IN THE MATTER OF COMPLAINT AGAINST THE EL SEGUNDO ENERGY CENTER PROJECT

COMMISSION ORDER ADOPTING THE SETTLEMENT AGREEMENT AMONG THE PARTIES TO THE COMPLAINT AGAINST THE EL SEGUNDO ENERGY CENTER

Joint Statement of Agreement

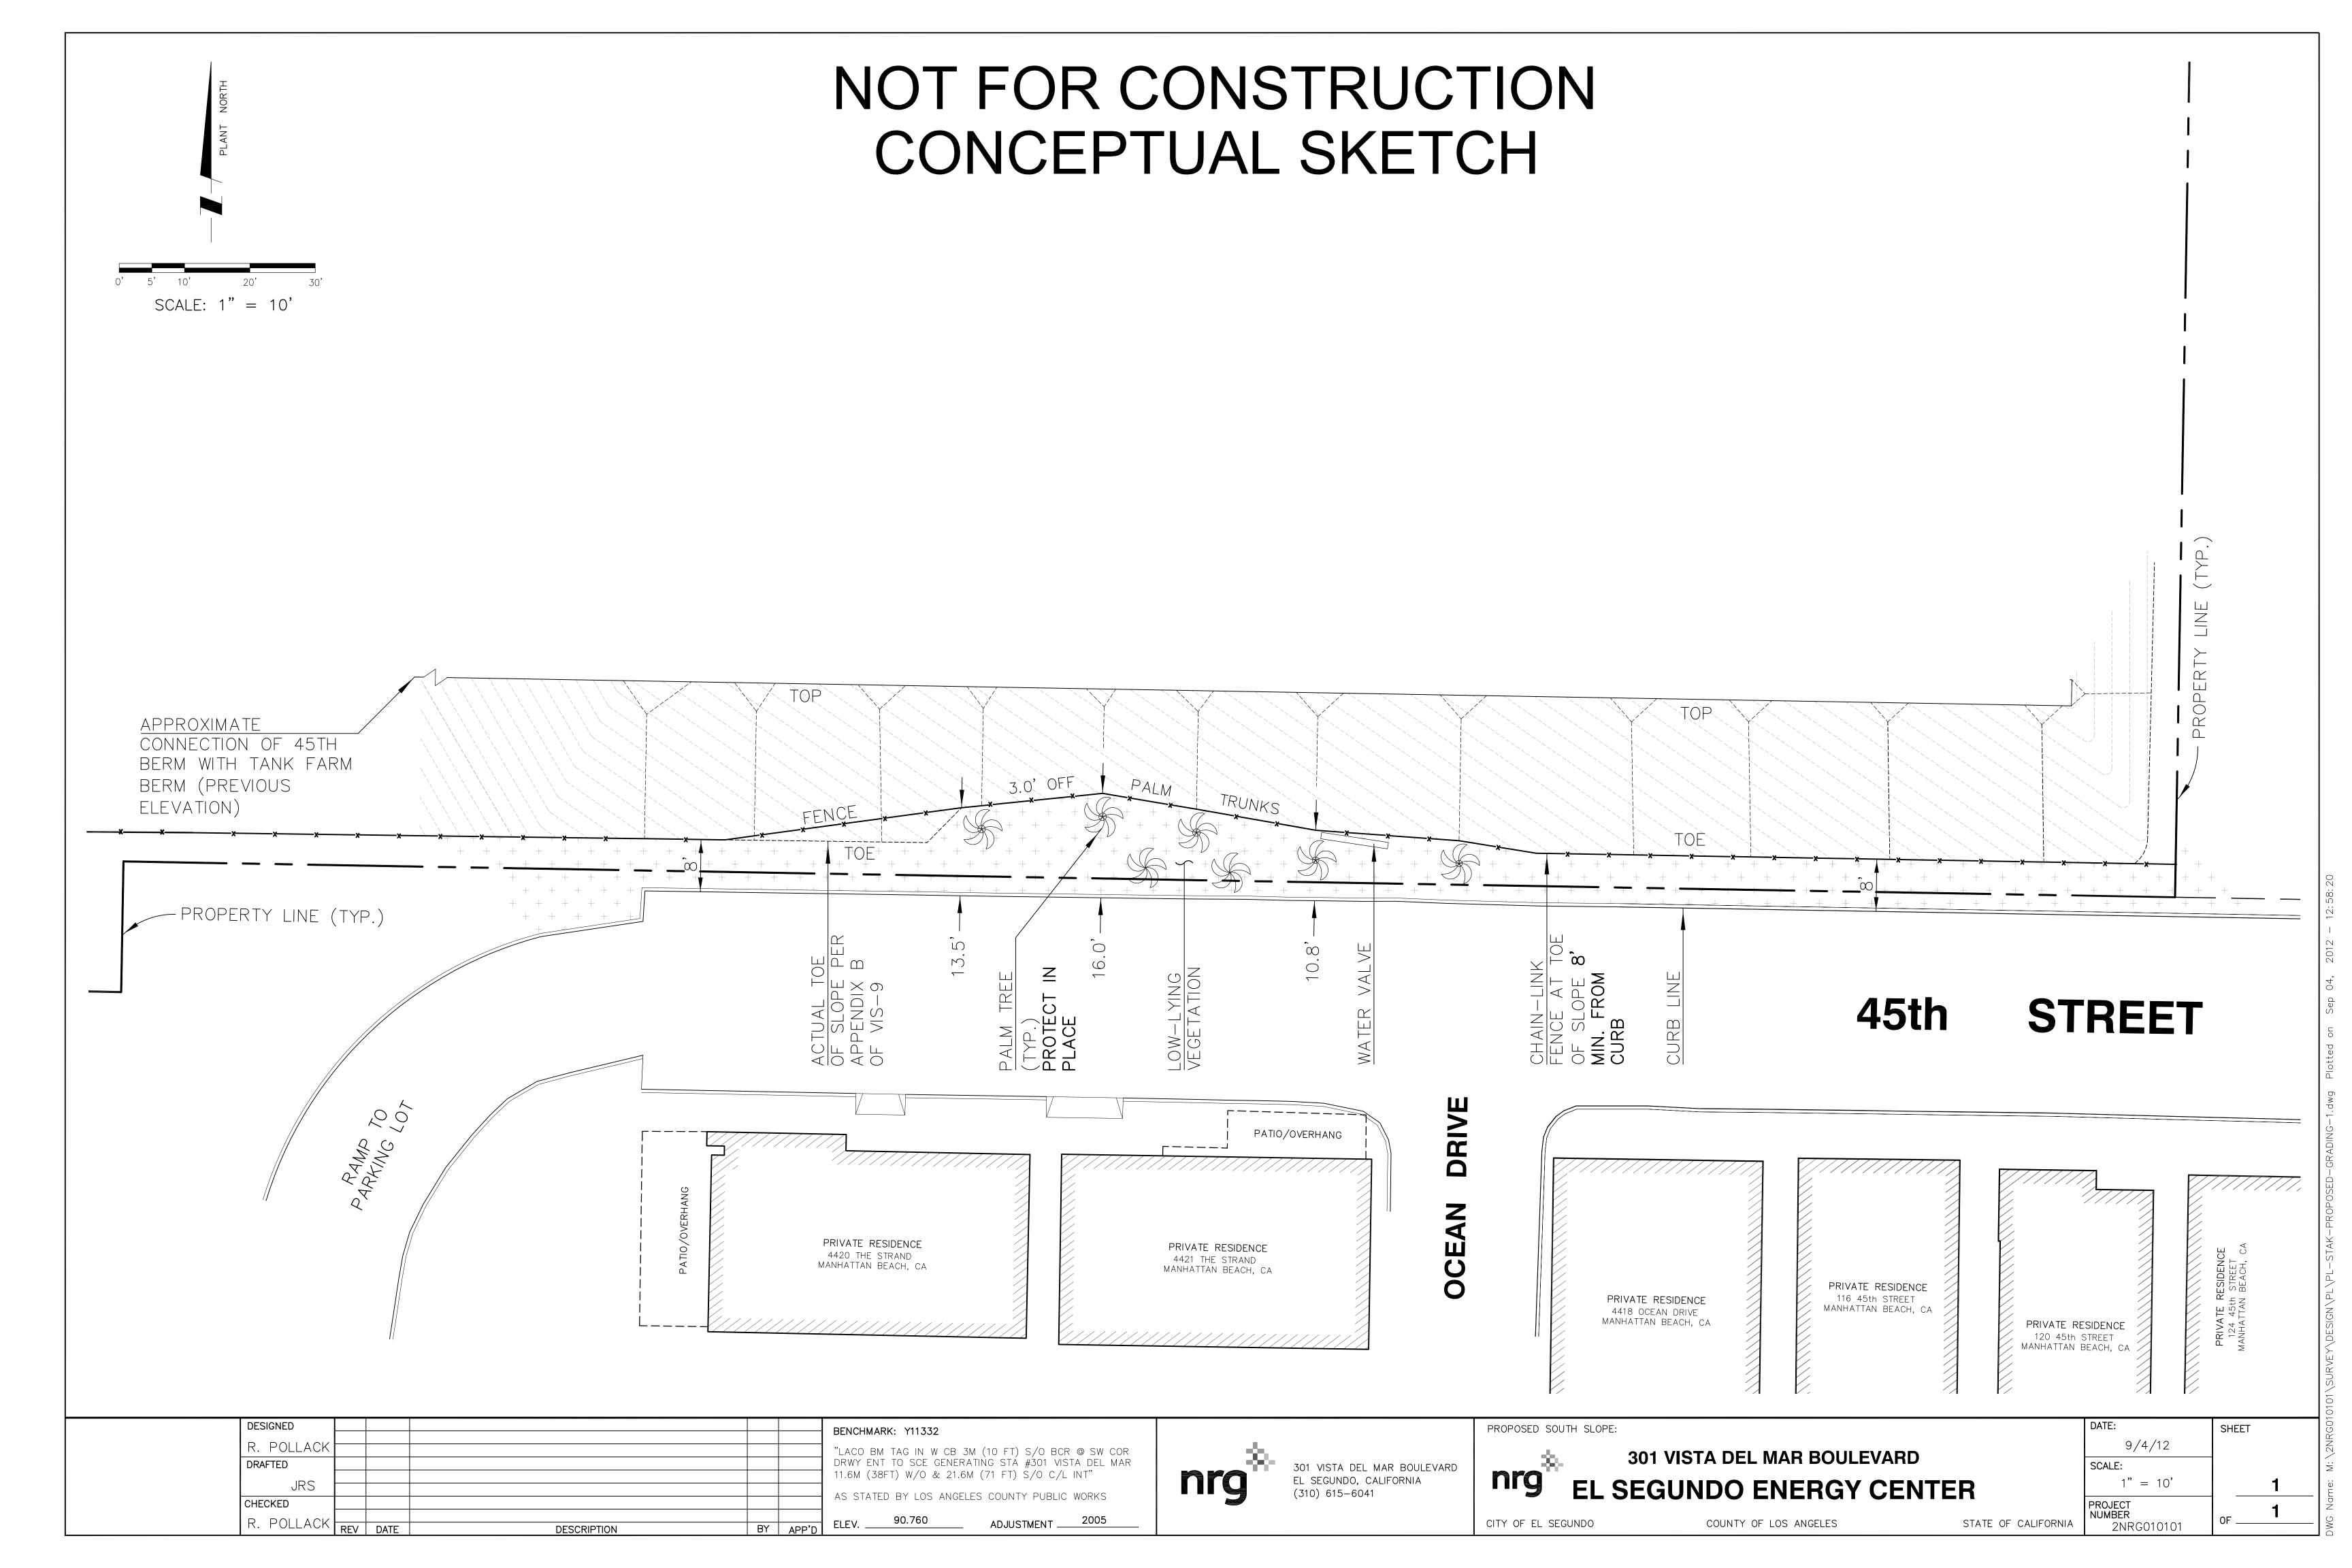
- a. The Parties jointly agree that the steepness of slope of the new 45th Street berm shall be increased in the area of the existing potable water valve and existing palm trees so the toe of the slope doe not reach the trees and that the existing palm trees shall be retained and incorporated into the landscaping. A general depiction of intended location of the toe of the slope is provided in Attachment A to this document.

- b. The Parties jointly agree that the final, permanent fence along 45th Street should be set back from the property line eight feet typical so as to maintain an area

similar to historic fence location. The Parties recognize that the exact location of the fence was never strictly decided in the past and that documents differed on its location. The Parties also acknowledge that a temporary fence on the southern property line is necessary during construction of the southern area landscaping features but that it will be replaced with the permanent fence promptly upon completion of the landscaping along the southern perimeter. A general depiction of the intended location of the fence is provided in Attachment A to this document.

- 5) ESECL agrees to prepare and submit to the City of Manhattan Beach, the City of El Segundo and the Parties for comment and then to the Compliance Project Manager (CPM) for approval, a revised 45th Street Berm Drawing (Appendix B to the *Temporary Landscaping and 45th St. Berm Vis-9* landscaping plan) that reflects the increased slope steepness to pull the slope back from the existing palm trees. The drawing should be consistent with the sketch provided as Attachment A.
